FAQ Number 17-0013 **FAQ Revision** 0 (Draft ~~BC~~)
FAQ Title High Energy Arcing Fault (HEAF) Non-Suppression Probability (NSP)

Plant: Various Date: ~~March 21, 2017~~ January 18, 2018
Contact: Beth Meade Phone: (508) 532-7139
Mark Schairer (508) 532-7317
Mark Humphrey (508) 532-7269
Email: bah@epm-inc.com
mvs@epm-inc.com
msh@epm-inc.com

This FAQ provides an update to the non-suppression probability (NSP) for high energy arcing fault (HEAF) fires based on a review of additional fire event data.

Figure 5-2
Non-suppression curve plots: probability vs. time to suppression

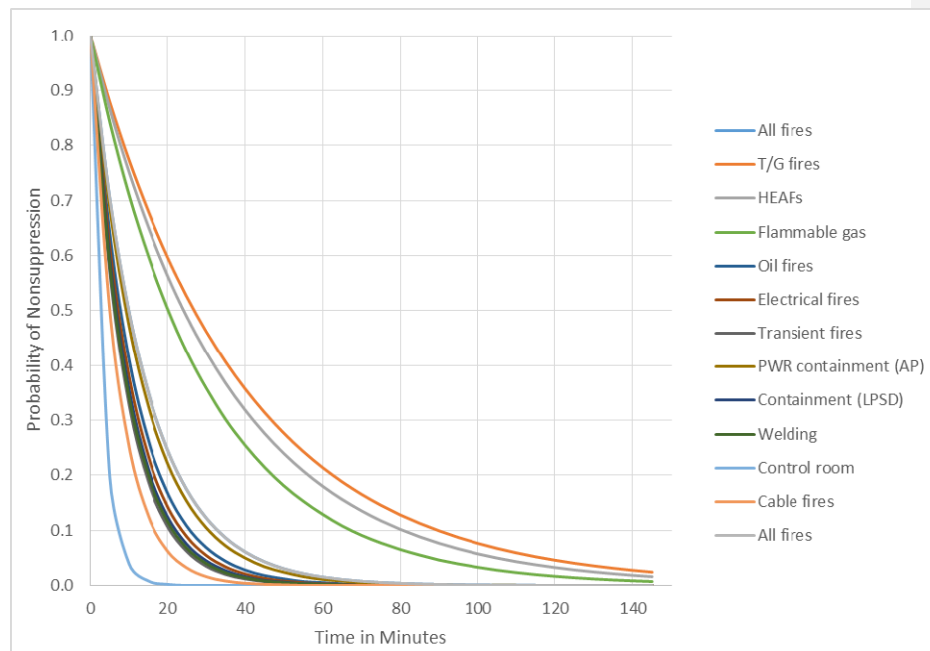
The re-binning of Fire Events #792 and #922 as HEAF fires versus electrical fires for the non-suppression probability necessarily results in a revision to the electrical fire non-suppression probability. The changes are reflected in the proposed revisions to NUREG-2169 included as part of this FAQ.

Based on the documentation review and considering the expanded data set, the mean suppression rates proposed in NUREG/CR-6850 Supplement 1 and NUREG 2169 are overly conservative. It is proposed that the mean suppression rate should be increased by approximately a factor of two (from 0.011/0.013 to 0.029) to reflect the revised average fire duration for HEAFs originating in high energy equipment in the US.

The following are proposed revisions to NUREG 2169:

Table 5-2
 Updated numerical results for suppression curves (Originally, Table 14-1 from NUREG/CR-6850, Supplement 1)
